Access Compliance Report

Public Rights-of-Way

(Curb Ramps)

Intersection ID: 28438	Main Street: JESSICA_PL	Cross Street: PROSPERITY_VILLAGE_DR	Location: NW
ADA ID: 47E09F8B4D89	Ramp Type: Perp	Initial Pass/Fail: Fail	Overall Compliance: No
			Severity Score: 33.75

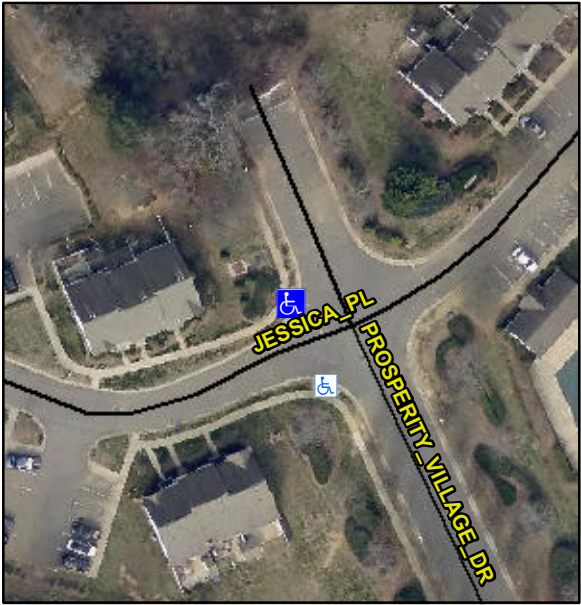
Codes/Mitigation Info/Possible Solution			Field Measurements/Component Compliance		
	Possible Solutions:		Compliance	Description	Data
	Remove & Replace Entire Ramp.		N/A	Ramp Length (in)	50.0
			No	Ramp Width (in)	42.0
			N/A	Flare Type LT	N/A
			N/A	Flare Slope LT (%)	N/A
			N/A	Flare Traversable LT?	N/A
			N/A	Landing Length (in)	N/A
			N/A	Landing Width (in)	N/A
			N/A	Landing Slope (%)	N/A
			N/A	Landing X Slope (%)	N/A
			N/A	Landing Curb? (Y/N)	N/A
			N/A	Shared Landing?	N/A
			N/A	Gutter Ponding?	N/A
			N/A	Gutter Lip Ht (in)	N/A
			N/A	Painted X Walk1?	No
				X Walk 1 Direction	To S
			N/A	X Walk 1 Width (in)	N/A
				X Walk 1 Slope (%)	2.1
				X Walk 1 X Slope (%)	6.8
			N/A	Ramp inside XWalk1?	N/A
<p>Surveyor Notes:</p> <p>N/A</p> <p>PROW/ADA:</p> <p>R304.5.1, R304.2.2, R304.5.3</p>			N/A	Flare Type RT	N/A
			N/A	Flare Slope RT (%)	N/A
			N/A	Flare Traversable RT?	N/A
			N/A	DWS Provided?	N/A
			N/A	DWS Contrast?	N/A

N/A	DWS Length (in)	N/A
			N/A	DWS Full Width?	N/A
			N/A	DWS Offset (in)	N/A
			N/A	Gutter Slope (%)	N/A
			N/A	Gutter X Slope (%)	N/A
			N/A	Painted X Walk2?	N/A
				X Walk 2 Direction	N/A
			N/A	X Walk 2 Width (in)	N/A
				X Walk 2 Slope (%)	N/A
				X Walk 2 X Slope (%)	N/A
			N/A	Ramp inside XWalk2?	N/A
			N/A	Clear Space?	N/A
			N/A	Clear Space to XWalk (in)	N/A
			N/A	Storm Grate/Utility Hazard?	N/A
				Storm Grate/Utility Type	
<p>Total Cost:</p> <p>\$ 1850.00</p>			N/A		N/A
				Obstruction Type	
			Yes	Surface Condition? (G/P)	Good
